ATTACHMENT 9

**INDEPENDENT VERIFICATION CONTRACTOR (ORISE)
SAMPLING AND ANALYSES RESULTS**

SUBJECT: FINAL LETTER REPORT—VERIFICATION SURVEY OF THE PILE FAN SUMP TRENCH AND THE ASSOCIATED DRAIN PIPING SOILS THAT EXTENDED FROM BUILDINGS 801 AND 704 TO THE PFS, BROOKHAVEN GRAPHITE RESEARCH REACTOR, UPTON, NEW YORK

FIGURE 3: Pile Fan Sump Area – Measurement and Sampling Locations

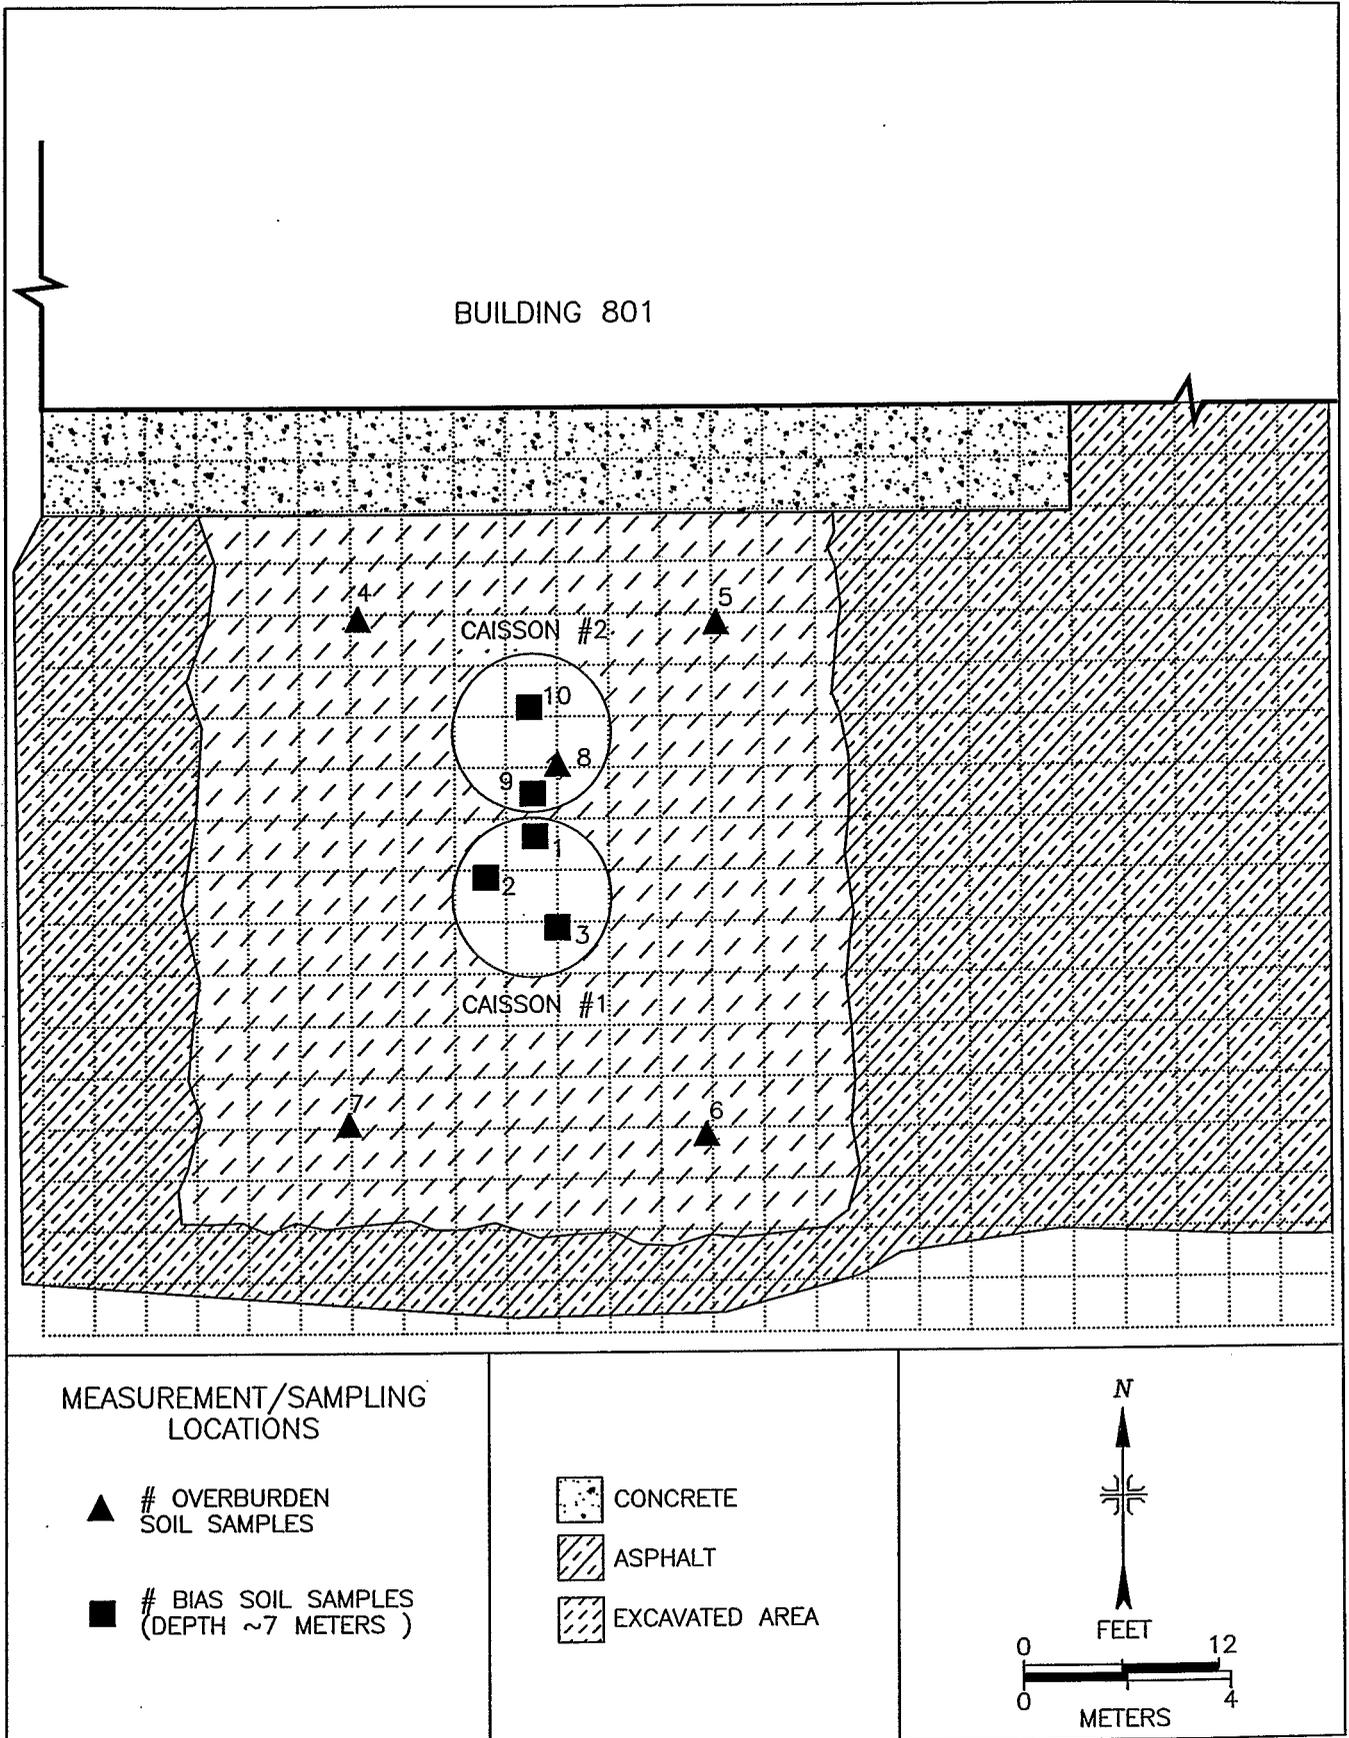
ESSAP's scans of the first caisson identified an area of elevated direct gamma radiation at the north-northeast corner, which concurred with BNL's findings. This area was marked for further evaluation. However, BNL decided to excavate the north-northeast area and use a second caisson. All gamma scans on the overburden soils in the PFS trench were at or near background levels.

ESSAP collected a total of ten soil samples from the exposed soil areas of the PFS trench (Figure 3). Three samples were collected inside the first caisson (0913S001 and 0913S003) and two inside the second caisson (0913S009 and 0913S010), following remediation. The remaining five samples (0913S004 through 0913S008) were from the exterior excavation areas outside of the caissons (overburden).
